**CITY OF WOODLAND PARK  
BOARD OF ADJUSTMENT AGENDA  
August 19, 2019 – 6:30 pm  
Woodland Park Council Chambers  
220 W. South Avenue, Woodland Park, CO**

| <b>SUBMISSION OF CERTIFIED RECORD<br/>         IN THE MATTER OF<br/>         THE APPEAL FROM THE ADMINISTRATIVE ORDER APPROVING<br/>         SPR 19-001 THE VILLAGE AT TAMARAC SITE PLAN (the "ORDER")</b> |  |                                                                    |

| <b>CITY RESPONSE TO PAUL B. NEAL III, DAWN C. NEAL, CAROLE MOLDEN,<br/>BROOKE SMITH AND KAROLYN SMITH APPEAL<br/>IN THE MATTER OF<br/>THE APPEAL FROM THE ADMINISTRATIVE ORDER APPROVING (SPR-19-001)<br/>THE VILLAGE AT TAMARAC SITE PLAN (the “ORDER”)</b> |  |                                     |

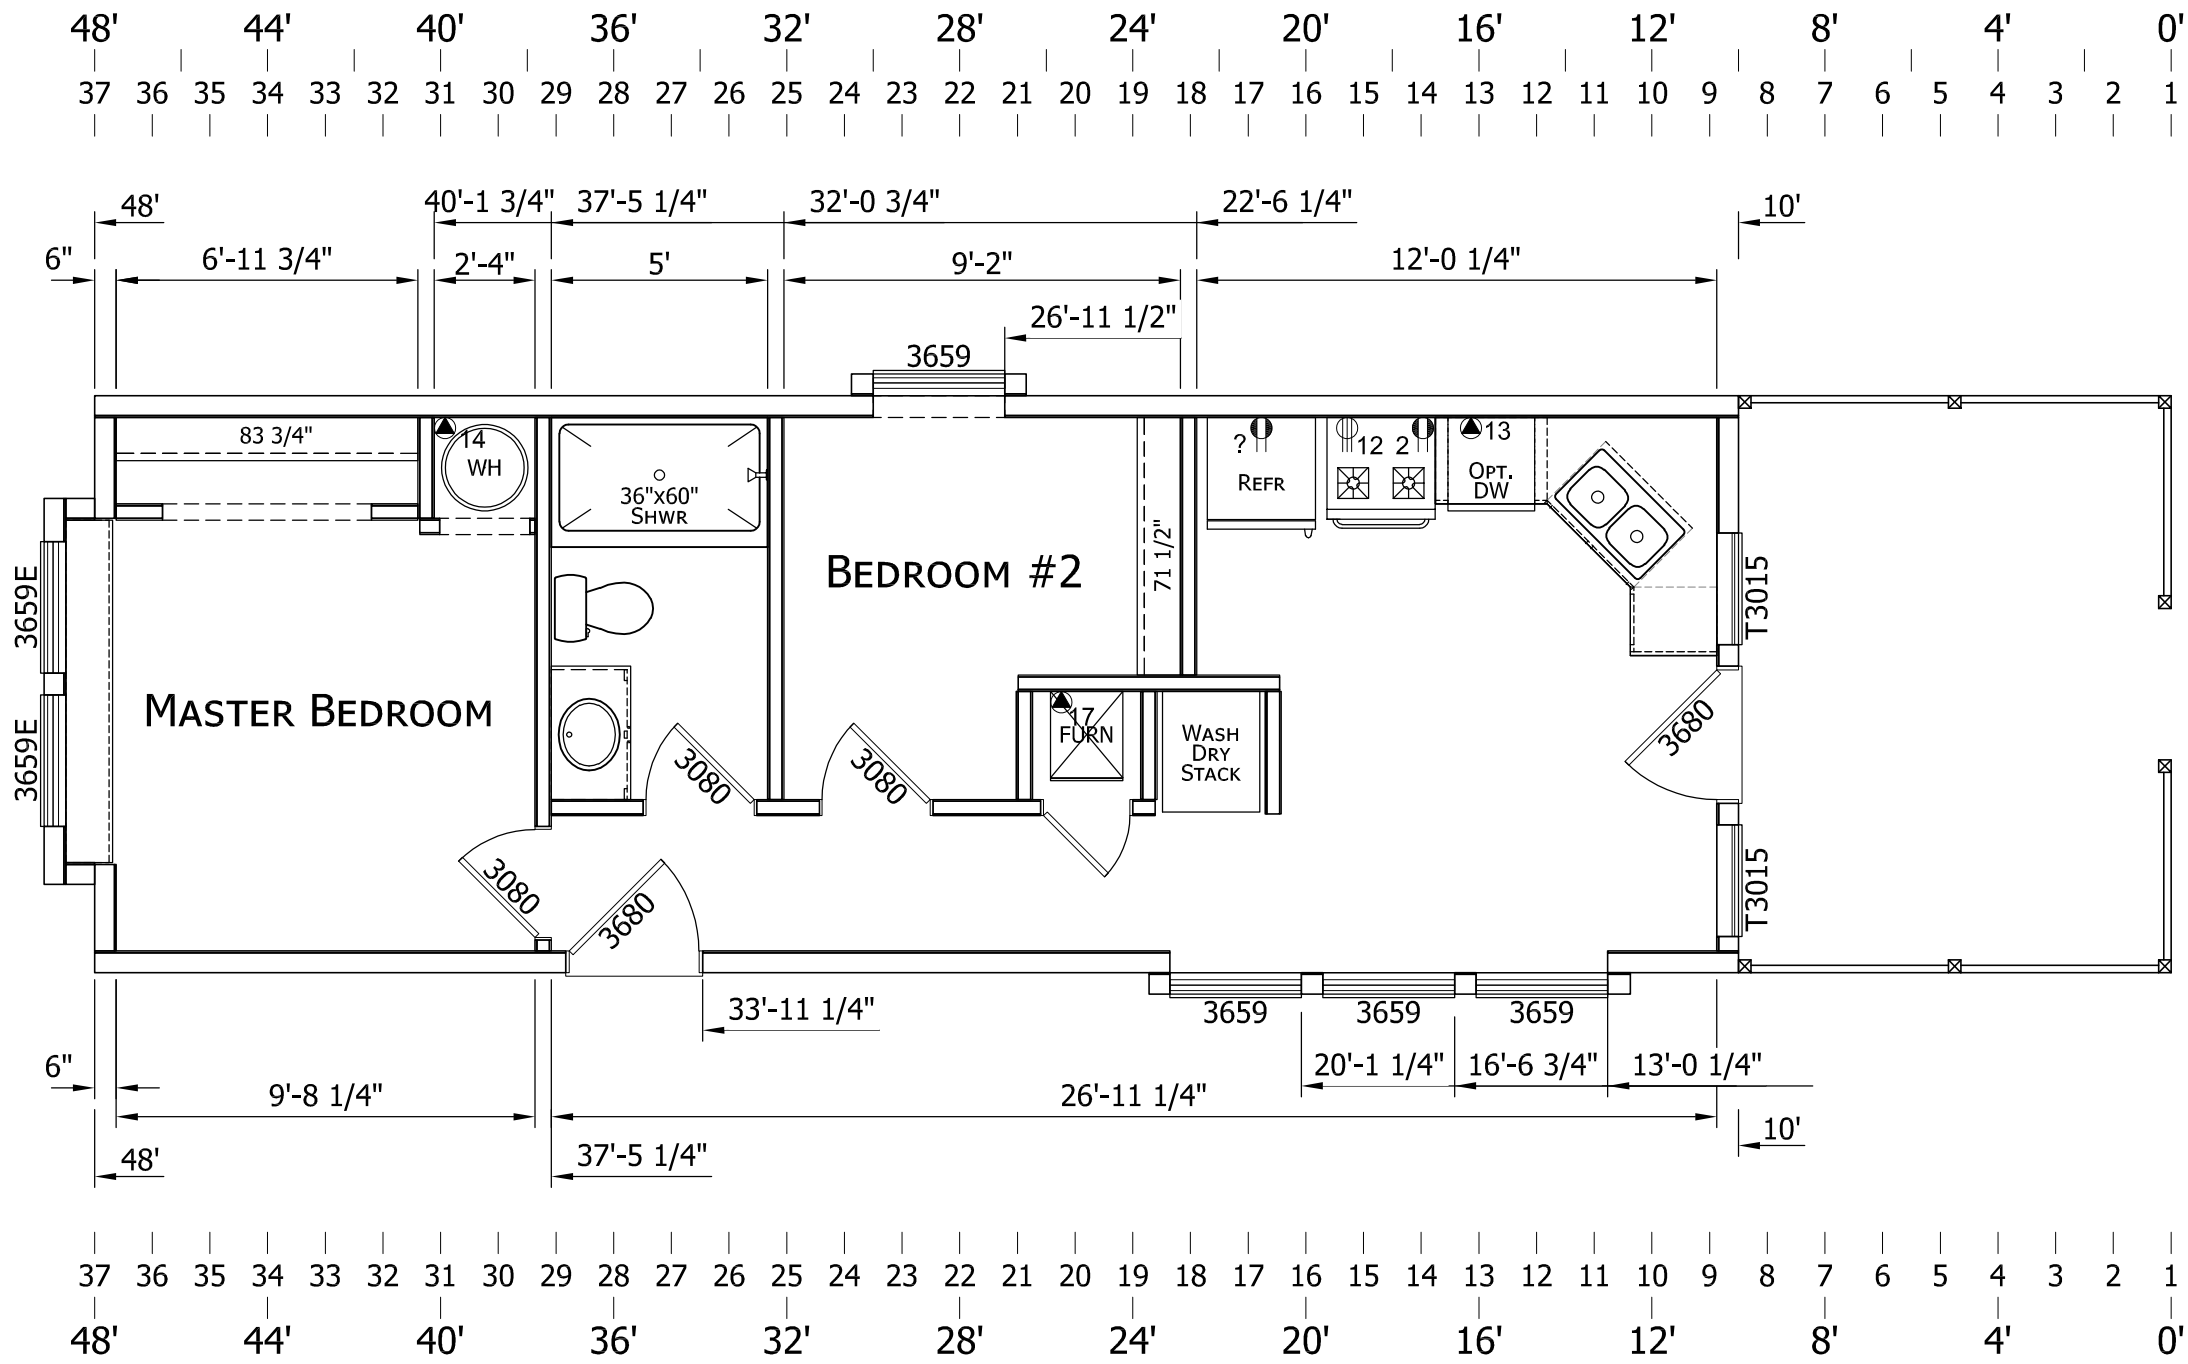
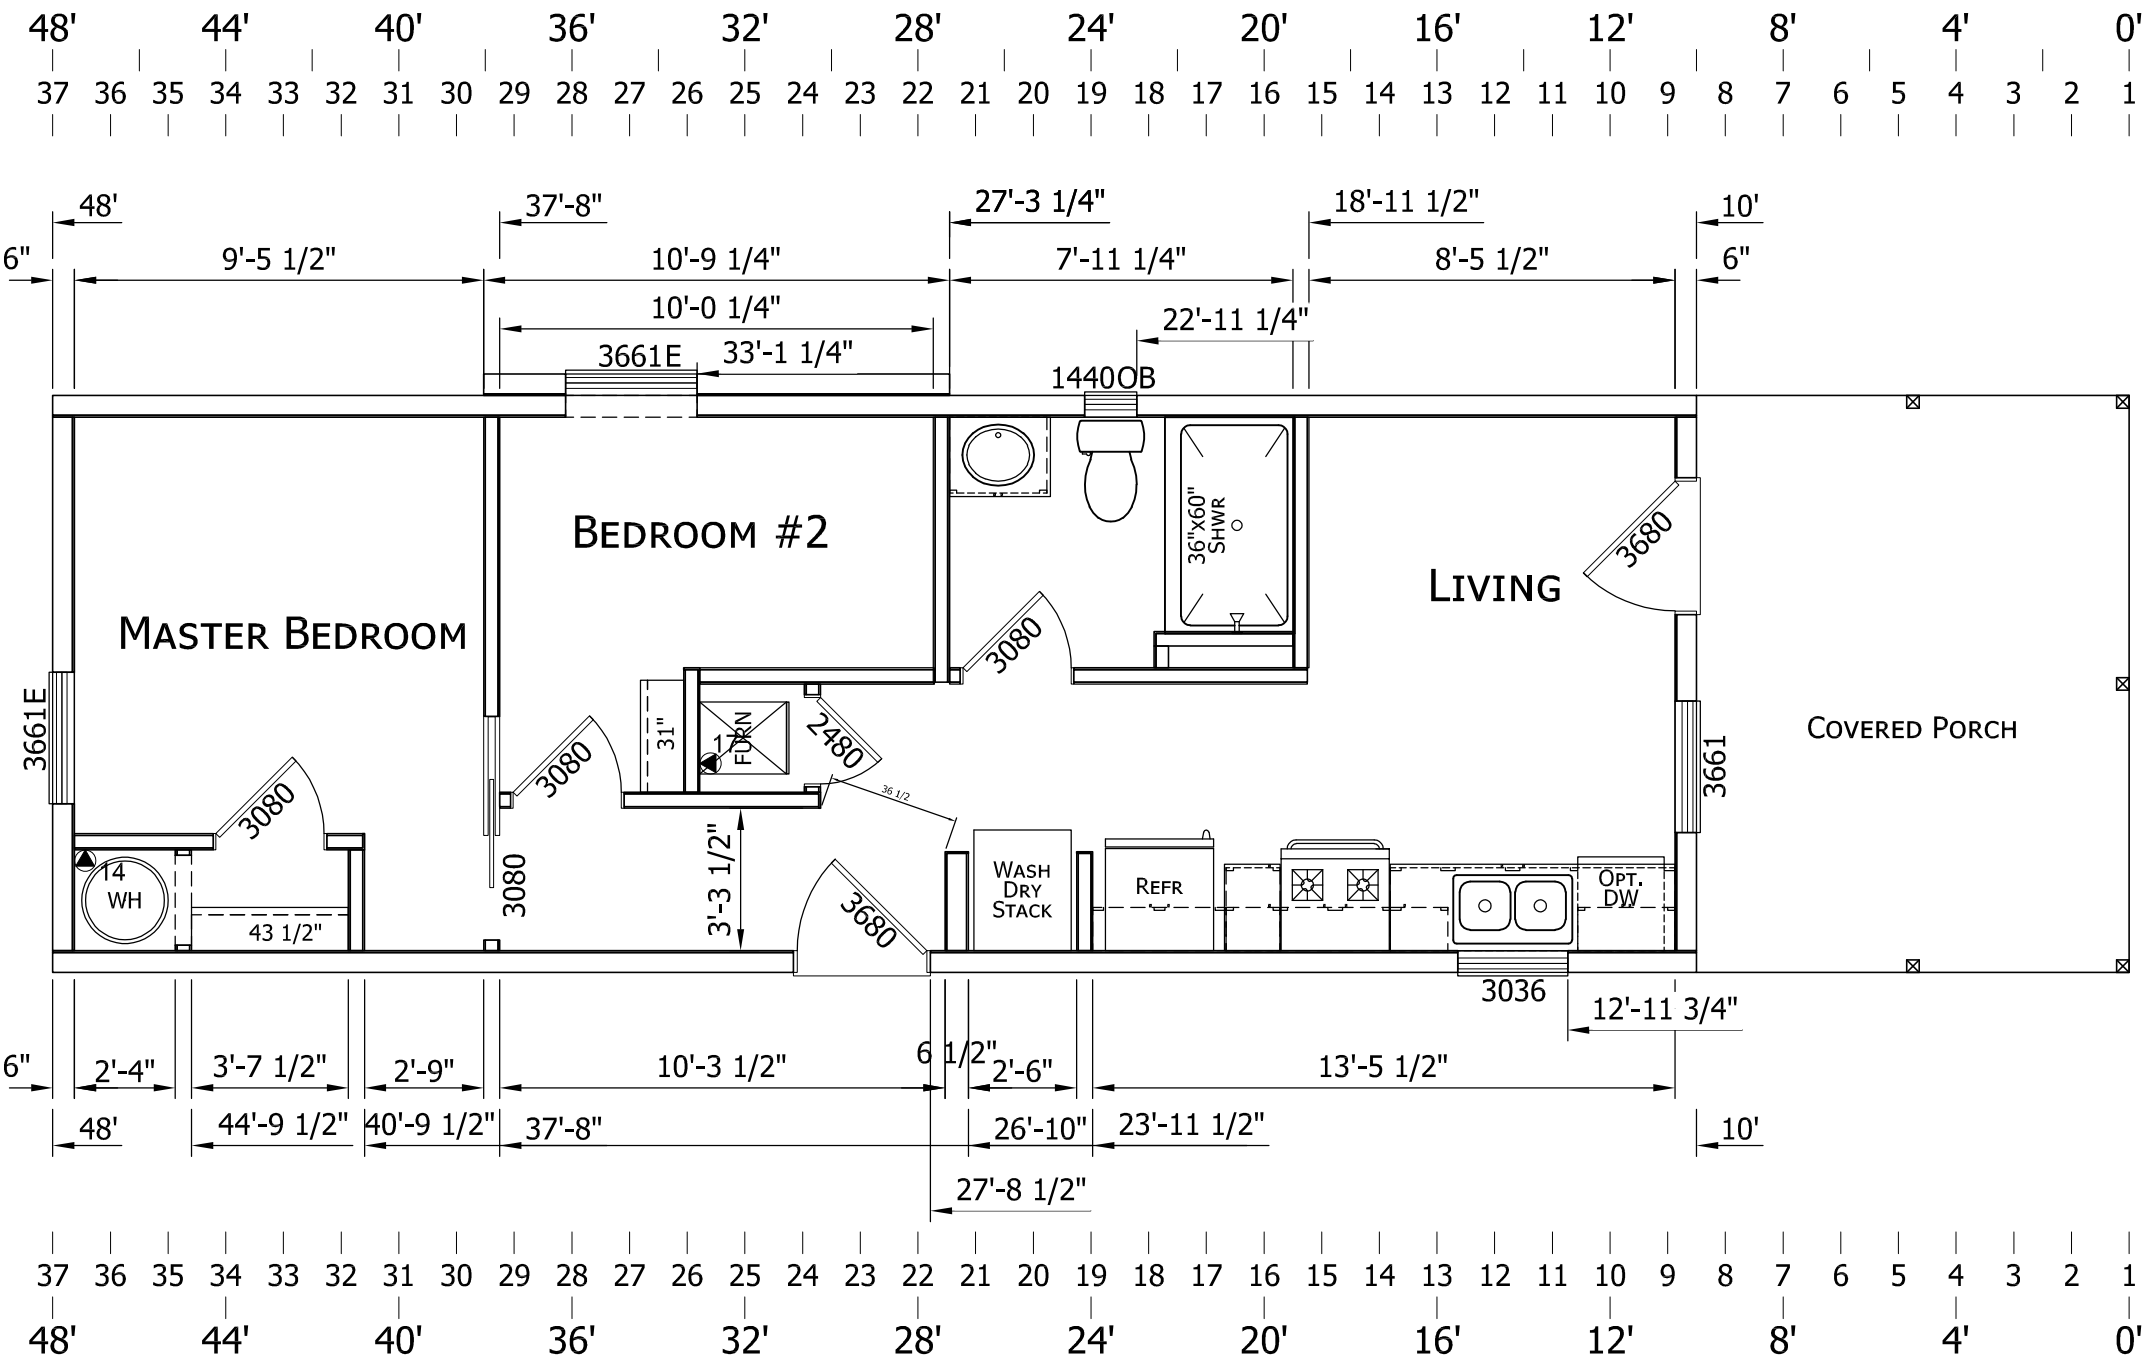
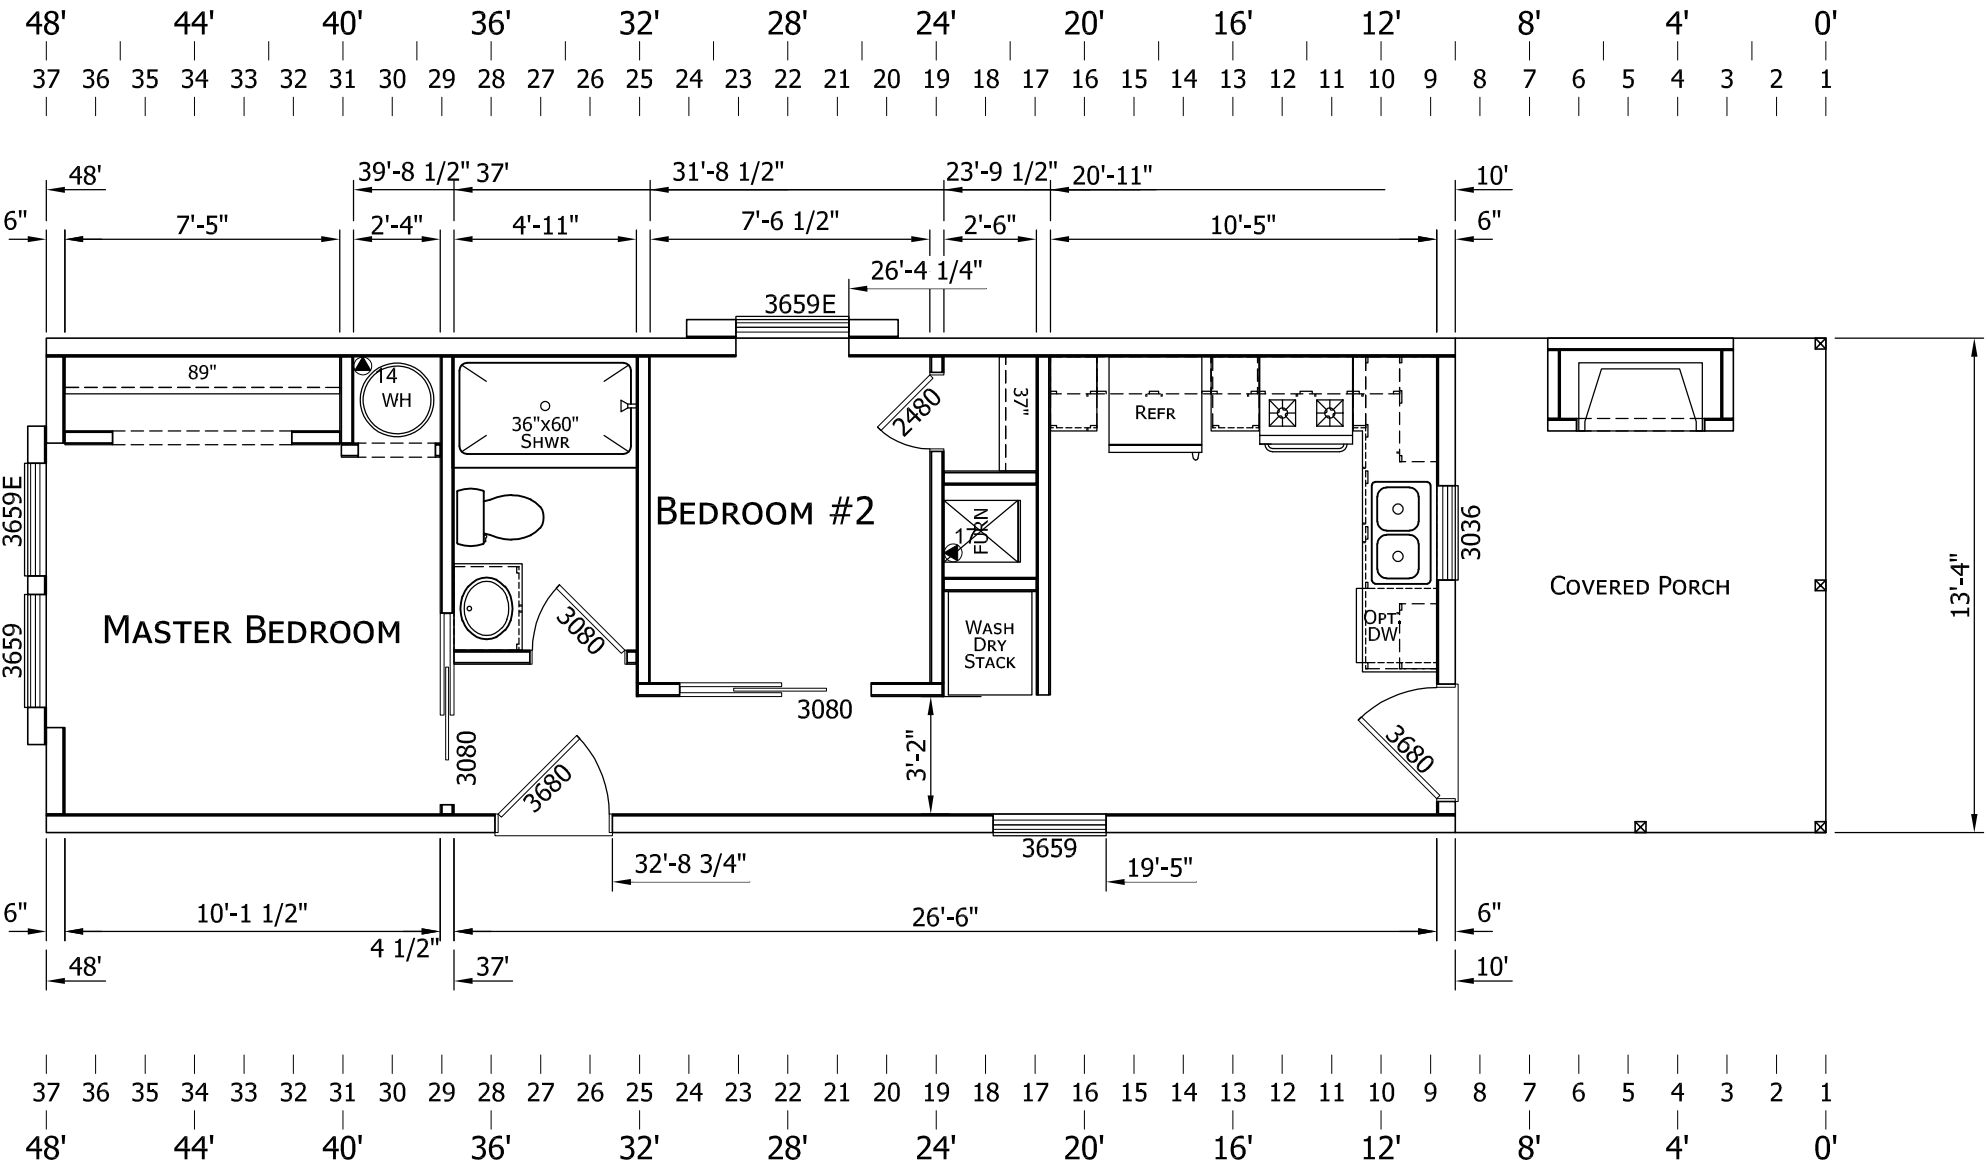
6. The Applicants failed to submit required documents per the initial Site Plan Review Letter (page 5, Architectural Exhibit (AE01), paragraph a.), “Elevations need to show more realistic representation of multiple units with scaled spacing, colors and materials. Specifically, a rendering to scale that depicts at least six units of different colors, design and porch styles shall be submitted.”

These discrepancies can be readily resolved by requiring the Developer to provide the actual floor plans of the units to be built. Architectural Exhibit AE01 only shows photographs of the Champion Home Park Model RV tiny home. That unit is only 399 sq ft. Yes, there is a "storage loft" in some units; however, that loft would not be included in the square footage calculation.

request to supplement Architectural Exhibit (Sheet AEO1). A color rendering of the elevations is not a City Code requirement and it was determined by the Staff that a rendering depicting two units side by side in 4 different color schemes was adequate.

**Complies.** A unified architectural style is provided with reference to building materials and design on Sheet AEO1. Due to Staff's concern about the density and repetitive nature of the building layout, a rendering to scale that depicts at least six units of different colors, design and porch styles is required. **A rendering was provided on July 18, 2019 with four units of different colors and designs.**
